UNITED STATES PATENT AND TRADEMARK OFFICE

Office Action Summary	Application No. 10/576,891	Applicant(s) DOERFEL ET AL.	
	Examiner Erica E. Cadugan	Art Unit 3726

DETAILED ACTION

Lines added by Examiner to show a sample of workpiece able to be engaged simultaneously by top and bottom spindles shown

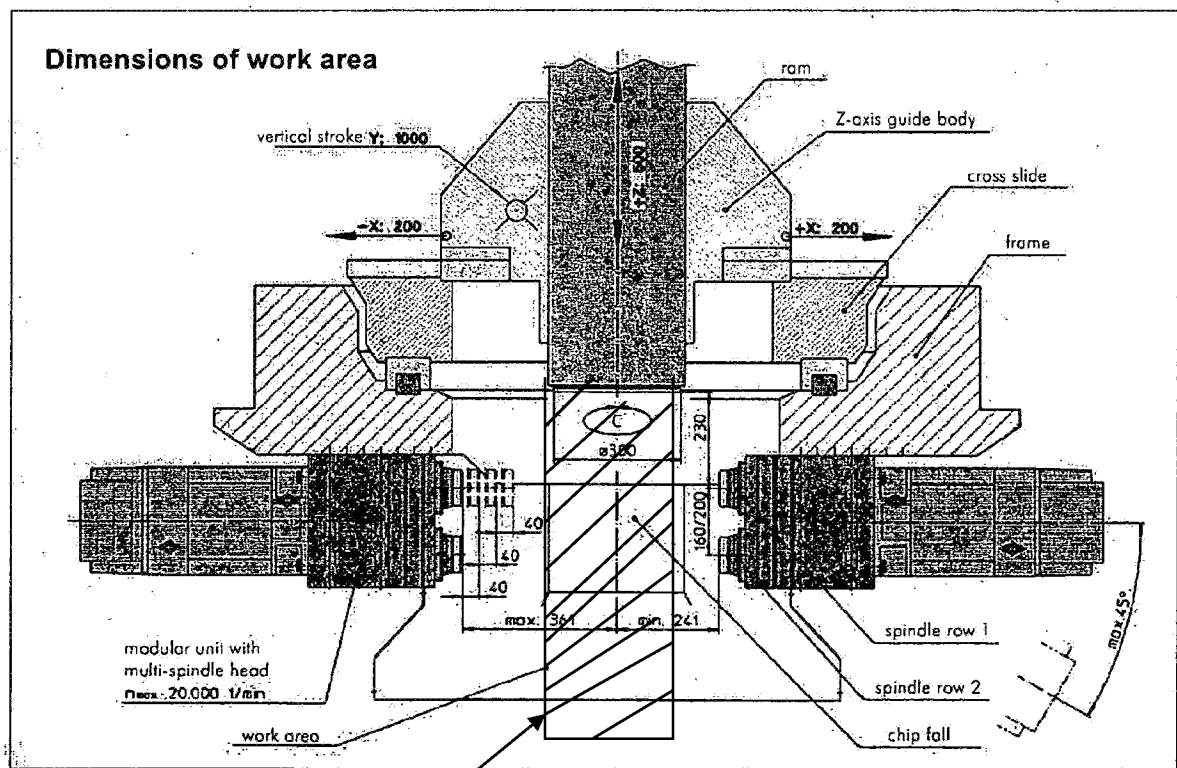
Noting the configuration of these “machine tools” shown in the figure at the bottom of page 7, these machine tools appear to be “identical” as claimed.

Alternatively, four spindles, i.e., a top and bottom spindle at a first Y-axis location on the right side of the figure at the bottom of page 7, plus a further top and bottom spindle at a second Y-axis location on the right side of the figure at the bottom of page 7, can be considered to form a “machining station”, with the one Y-axis location spindles constituting one “machine tool”, and the spindles at the second Y axis location constituting a further “machine tool”, which presents a different configuration of spindles of machine tools that are also shown in the photograph at the top of page 7 as being identical.

Re the limitation in claim 5 “the at least some of the tool spindles being arranged in a working space of the machine tool so that the machine tools fastened on them come into engagement simultaneously...”, noting the interpretation wherein top and bottom right side (right with respect to the figure at the bottom of page 7) spindles at one Y-axis location constitute one machine tool (see paragraph above beginning “[A]lternatively, four spindles...”), note that the machining tools held on right side top and bottom spindles at one Y-axis location are capable of simultaneously engaging a workpiece held by the ram (see the figure at the bottom half of page 7). See the labeled reproduction of the figure at the bottom of page 7 below for a showing of an example of a workpiece configured such that it is capable of being engaged simultaneously by the top and bottom shown spindles.

(Note that the claim is an apparatus claim rather than a method claim, and that all that is necessary to meet the claim language is that the prior art be capable of performing the claimed function of simultaneously engaging the workpiece.)

Alternatively/additionally, note that as shown in the figure at the bottom of page 7, the workpiece held in the ram is rotatable in the C-axis direction (i.e., rotatable about the vertical Y axis), and thus for at least this additional/alternative reason, the system taught by the brochure is considered to meet this broad limitation, noting that thus, the brochure system is capable of presenting the workpiece held by the ram to a machining station in one “orientation”, then rotating the workpiece in the C-axis direction to present the workpiece to a different work station in a different orientation, such as, for example, an orientation rotated by 90 degrees (about the Y-axis) with respect to the first orientation.
